PEARL BUILDING EAST

LU 16-153002 HRM AD

TYPE III REVIEW SUBMITTAL

EXHIBIT B

NORTH ELEVATION
02. WITH NEIGHBOR EASEMENT AGREEMENT

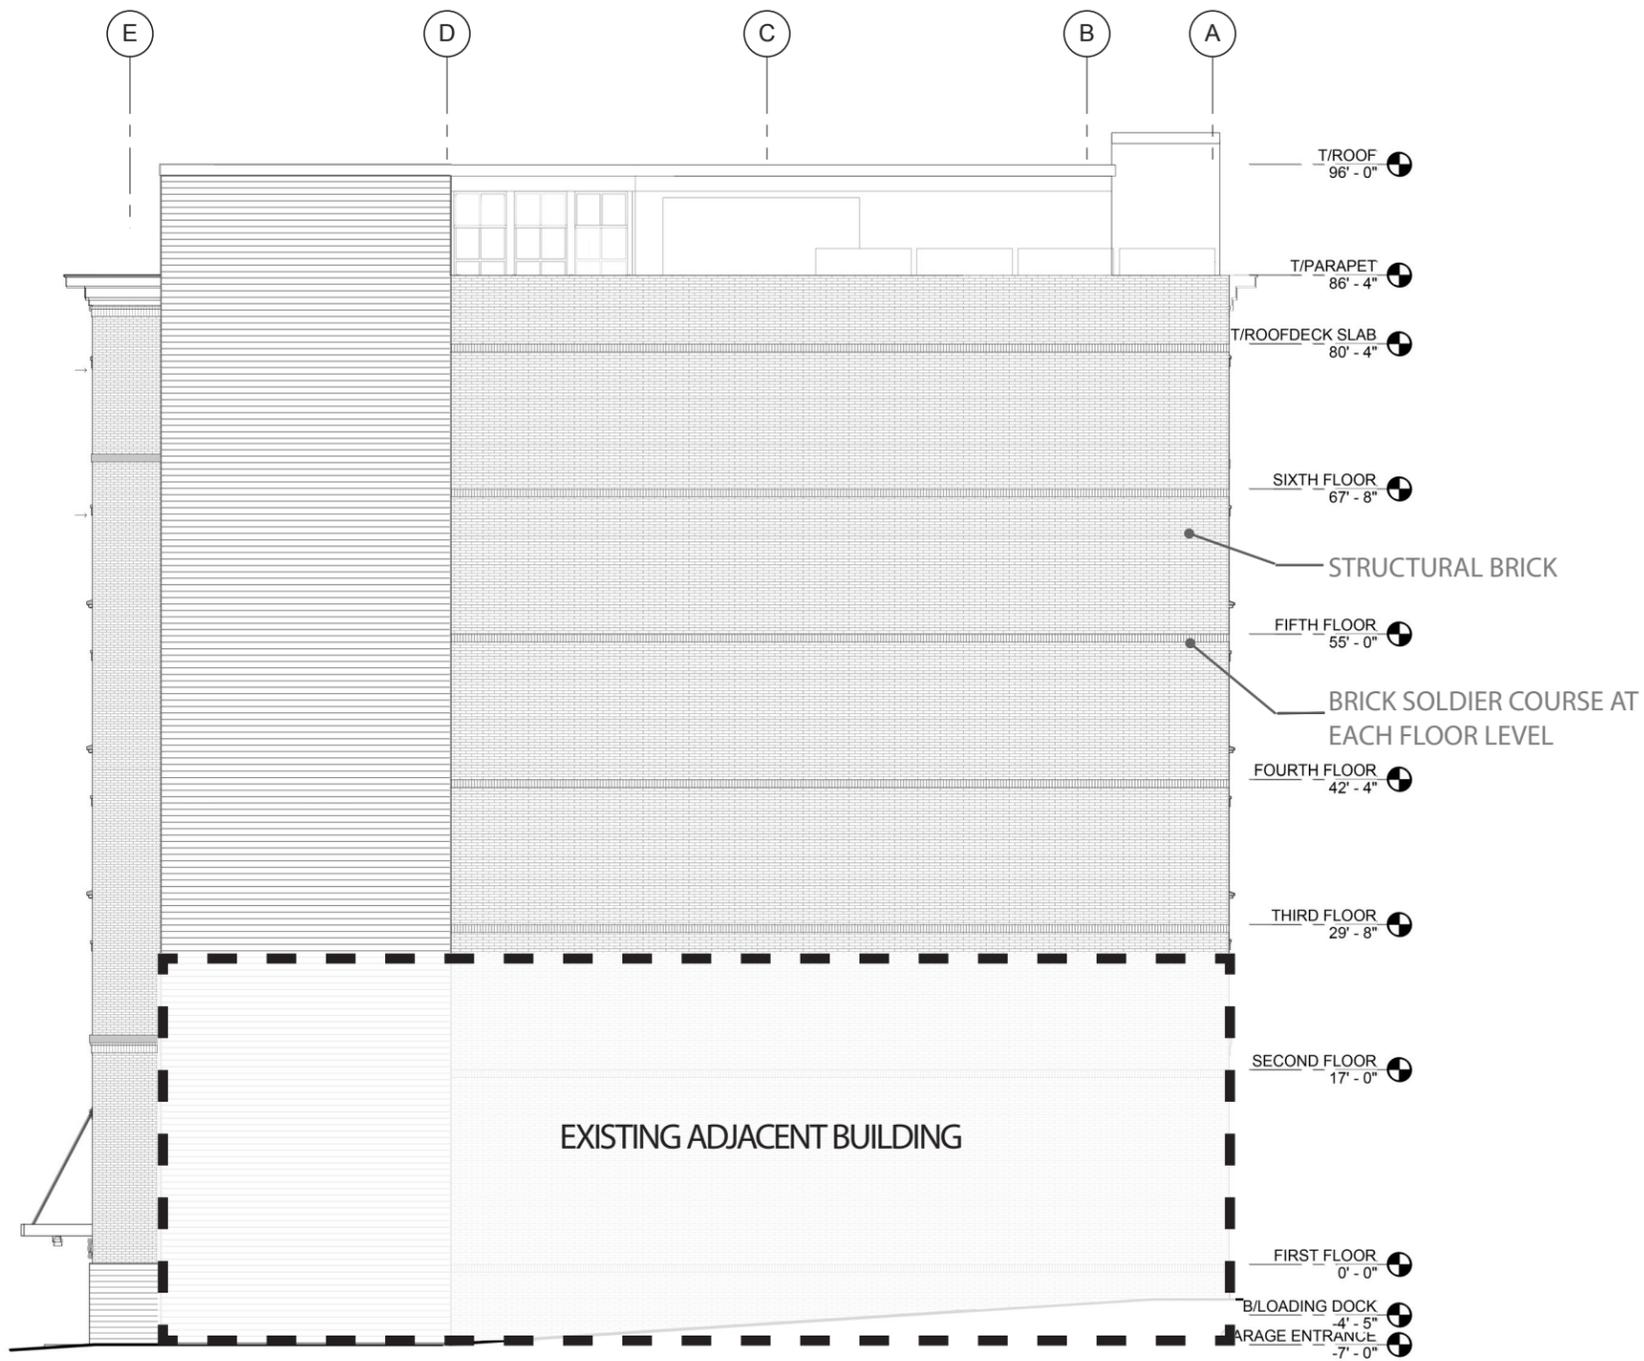
B. Proposed continuation of windows onto North facade is acceptable. Consider extending line of brick.

B. Pending agreement with neighboring building, project proposes extending brick line up to 70 feet on the North facade, with stuccoed or painted masonry adjacent to this brick.

RESPONSE: Due to the restrictions posed by property owners to the north, there is a strong possibility that construction techniques will be limited to laid-up CMU from the Project property. Concrete bands would naturally be expressed at floor lines. The Project is submitting one option to add windows in one bay should the neighboring property owners reach a construction agreement.

EAST ELEVATION
 (VIEW LOOKING WEST ON GLISAN ST.)
 1/16" = 1'-0"

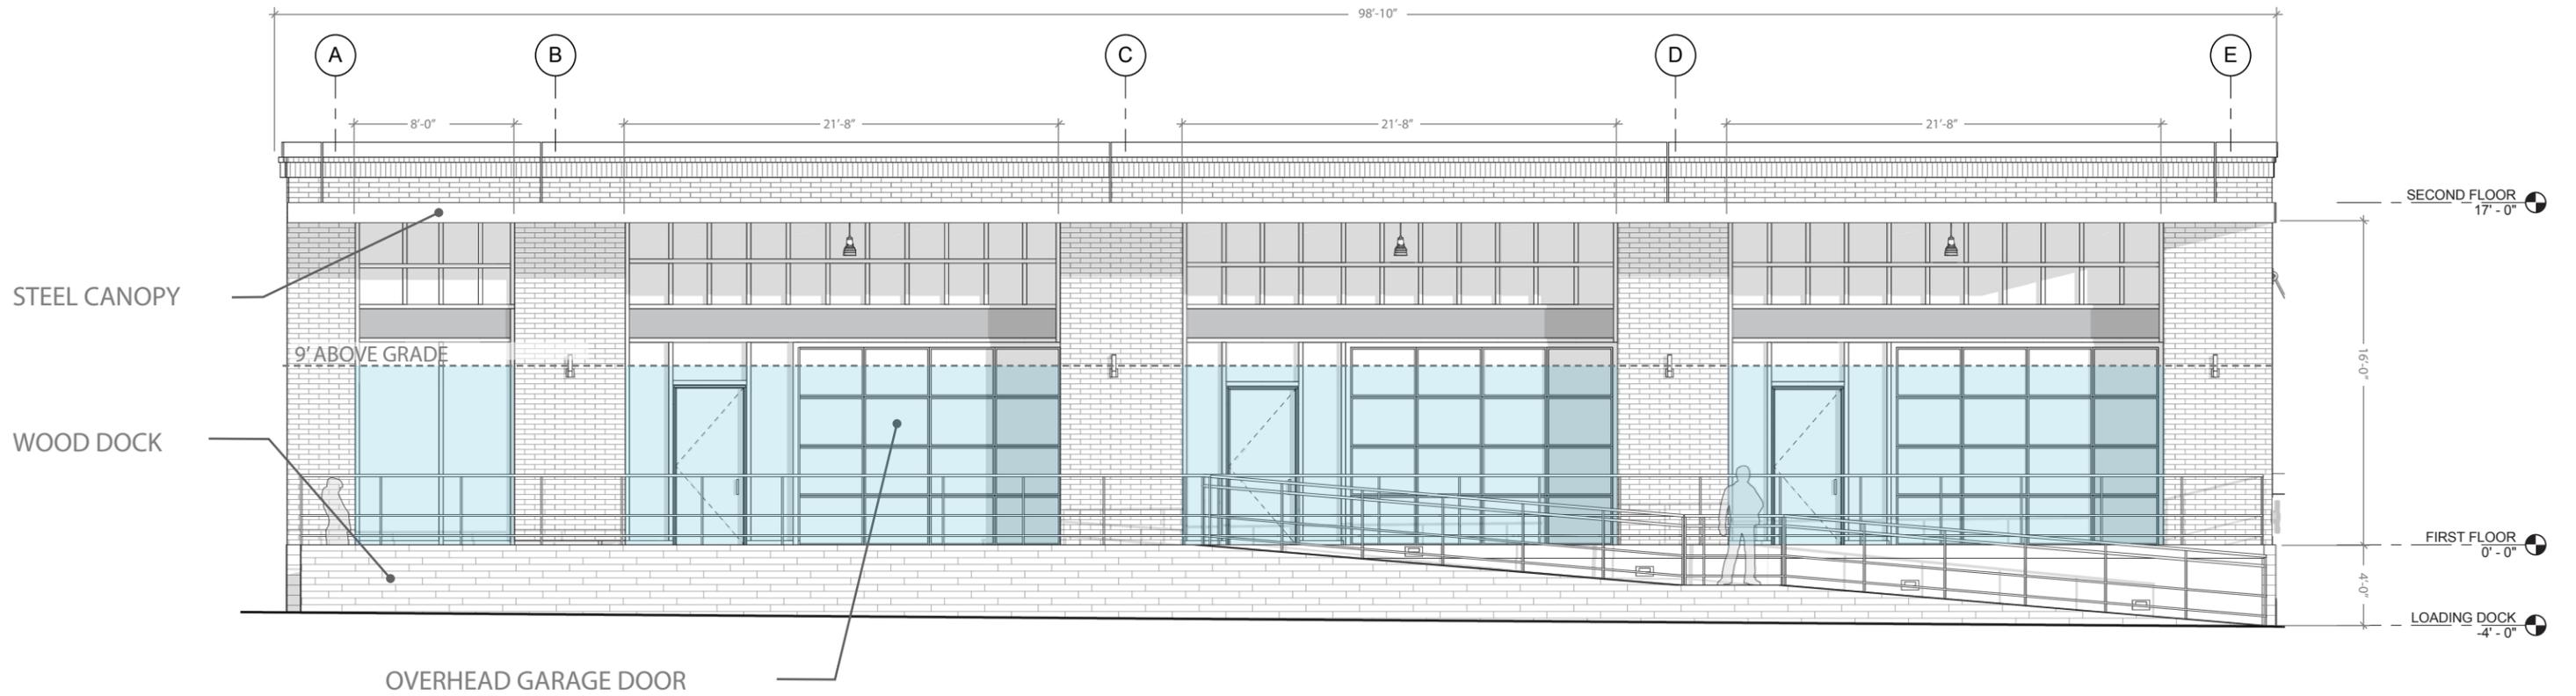
A. Proposed materials of blended brick, concrete, dark painted steel, and limited wood is appropriate. Consider less detailed treatment of "end" walls at North and East.

A. Project proposes simple stuccoed or painted masonry units at East facade.

F. GLISAN STREET VERTICAL LIFT GARAGE DOOR AND LOUVER ABOVE

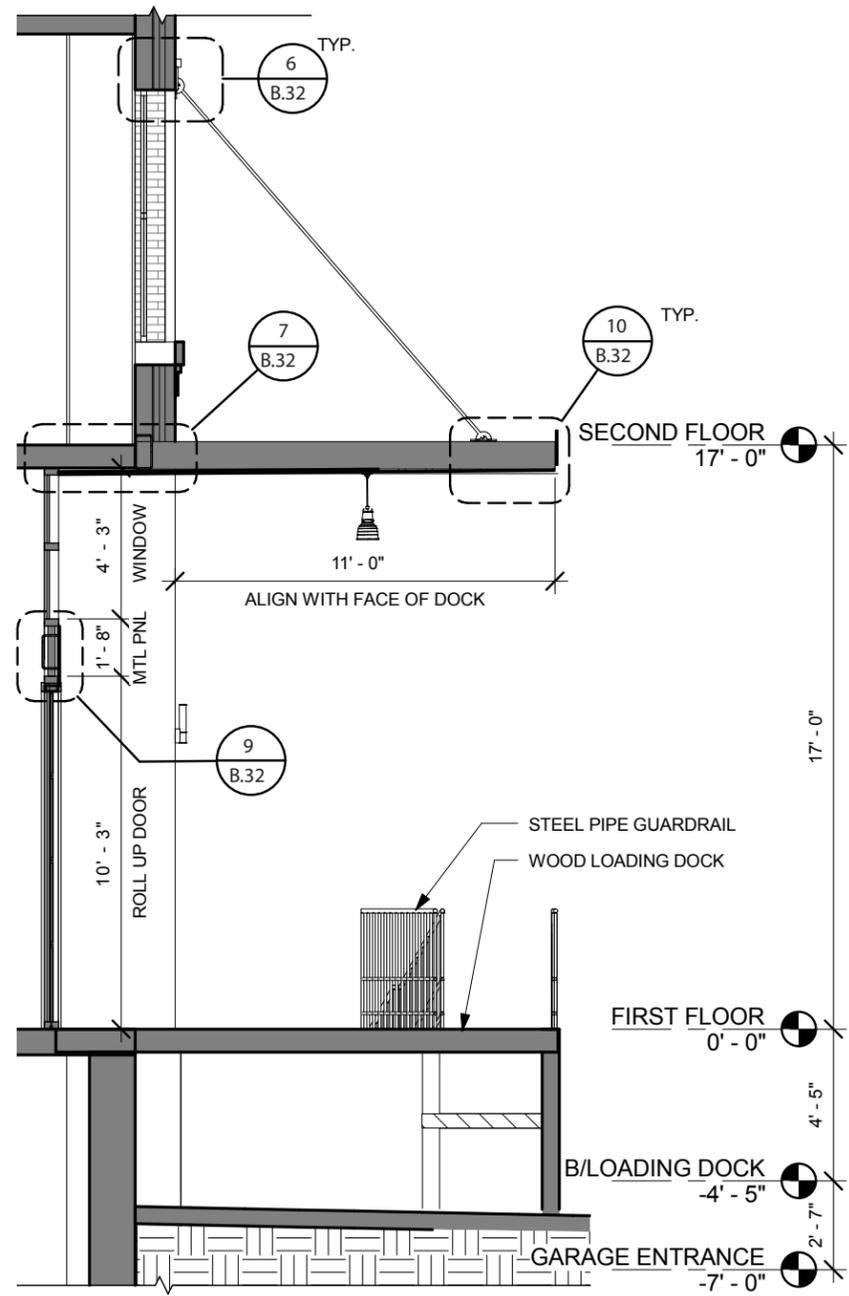
A. Consider decreasing the scale of the opening at the Glisan Street garage door.

1. LOWER AND/OR MITIGATE TALL HEIGHT OF GARAGE DOOR
2. REVISE THE GARAGE DOOR AND EXIT DOOR
3. BASEMENT LEVEL BELOW THE STOREFRONT WINDOWS NEEDS ADDITIONAL DESIGN REFINEMENT

A. Project proposes a canopy over the garage entrance to visually break up the scale of the opening, especially at the pedestrian scale.

1. RESPONSE: ADDED CANOPY AT A PEDESTRIAN SCALE TO BREAK UP PLANE OF OPENING. GARAGE DOOR AND LOUVERS SET BACK FOUR FEET TO CREATE ADDITIONAL DEPTH IN THE FACADE.
2. RESPONSE: ADJUSTED PATTERNING AND SEGMENTATION OF GARAGE DOOR AND LOUVERS. REMOVED WINDOW AND TRANSOM ABOVE EXIT DOOR TO ESTABLISH HIERARCHY.
3. RESPONSE: ADDED DECORATIVE LOUVERS BELOW RETAIL WINDOWS TO BREAK UP CONCRETE BASE.

Enlarged Elevations at Penthouse/Roofdeck: 1/8" = 1' - 0"

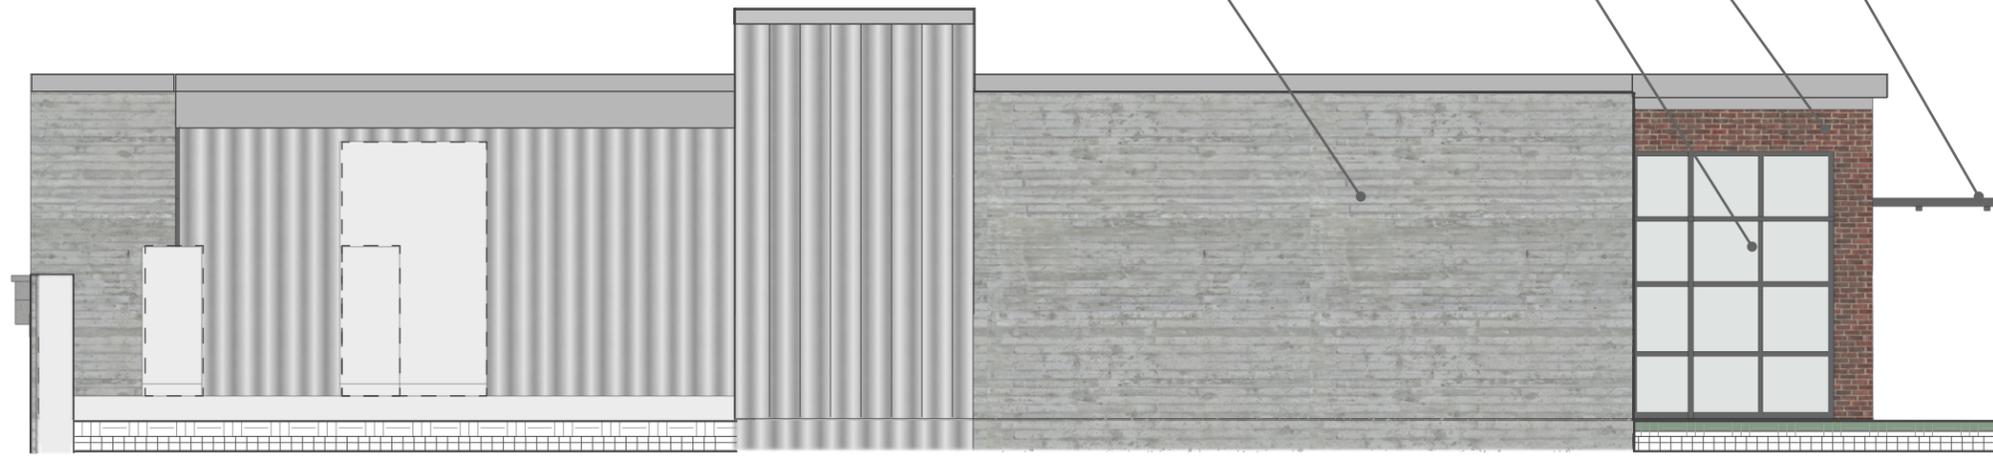
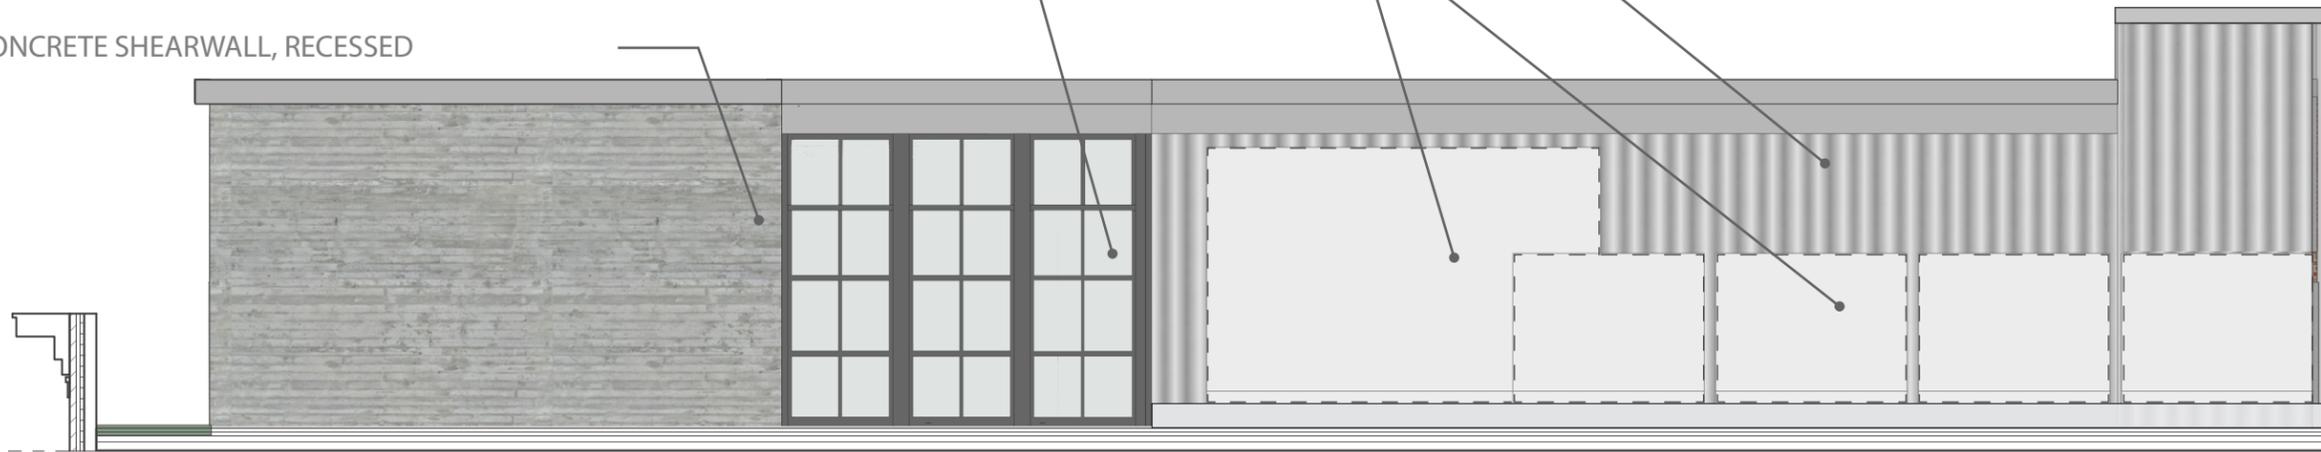
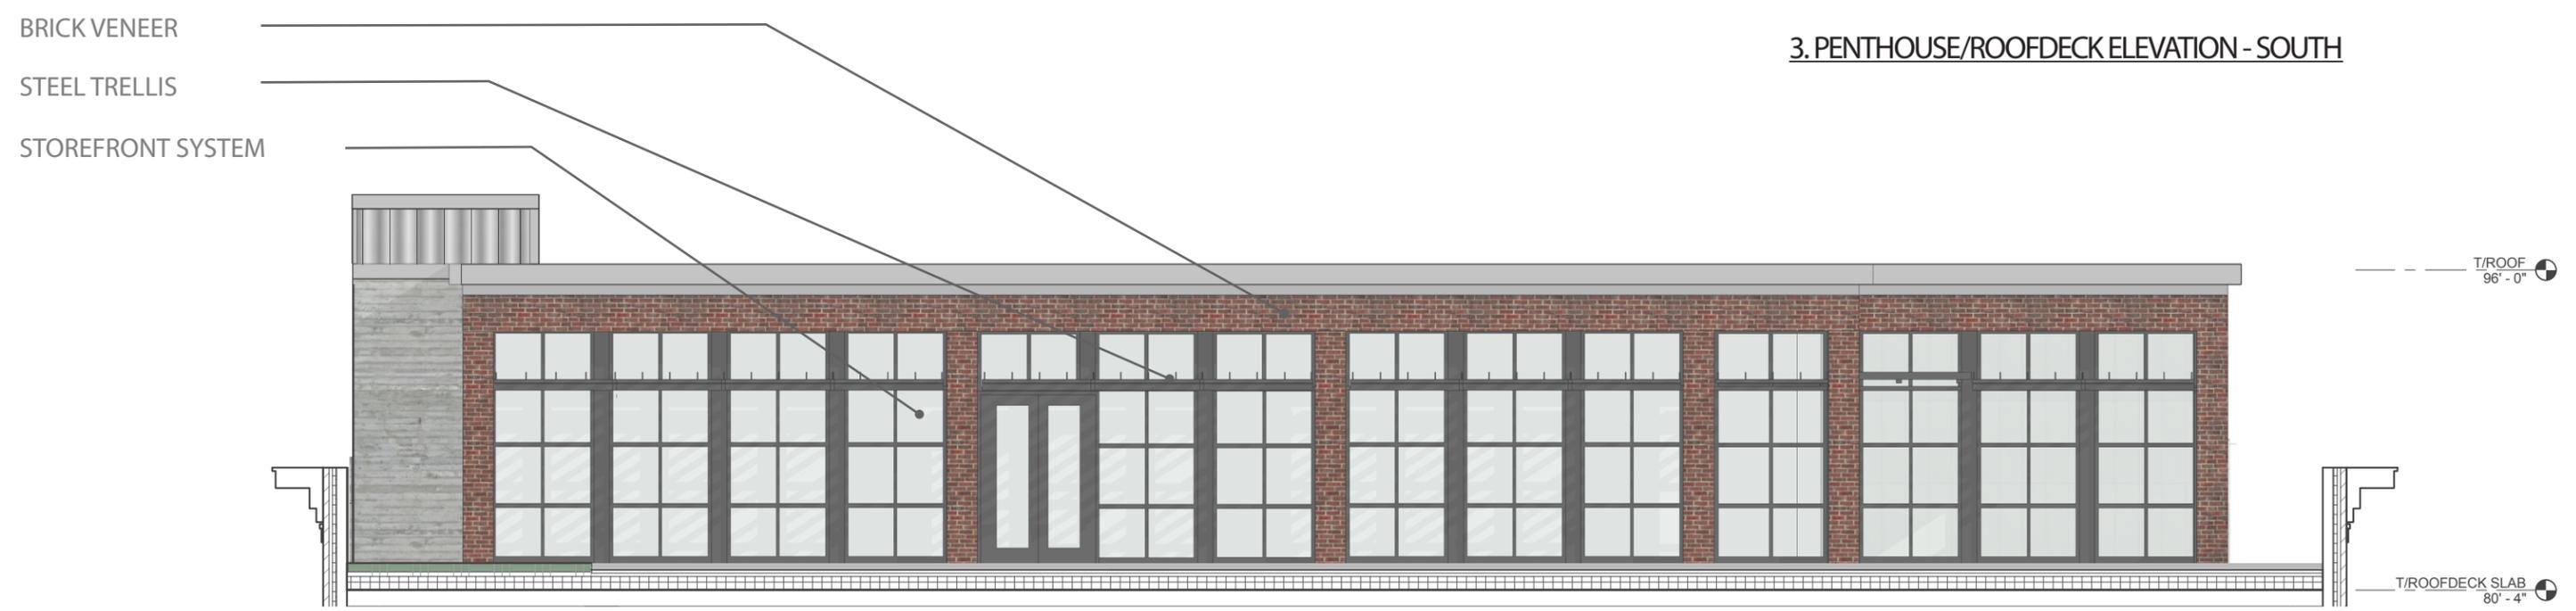
A. Consider simple, industrial style for penthouse materials that do not distract from main brick mass of the building.

B. Penthouse elements should not cause the building to appear as a 7-story building.

A. Proposed materials are light colored to blend into sky and not distract from the bulk of the building.

B. Project proposes that penthouse elements are set-back and disconnected from the planes of major facades. The parapet acts as a natural guardrail so no additional guardrail element is needed. The deep cornice reduces sightlines of the penthouse from the street.

RESPONSE: Proposed penthouse materials are light-colored metal panel to blend into sky when viewed from the street and not distract from the bulk of the building. The mechanical equipment has been sized to be hidden by the parapet only with no additional screening required. Additional views of this area are provided in the Application.
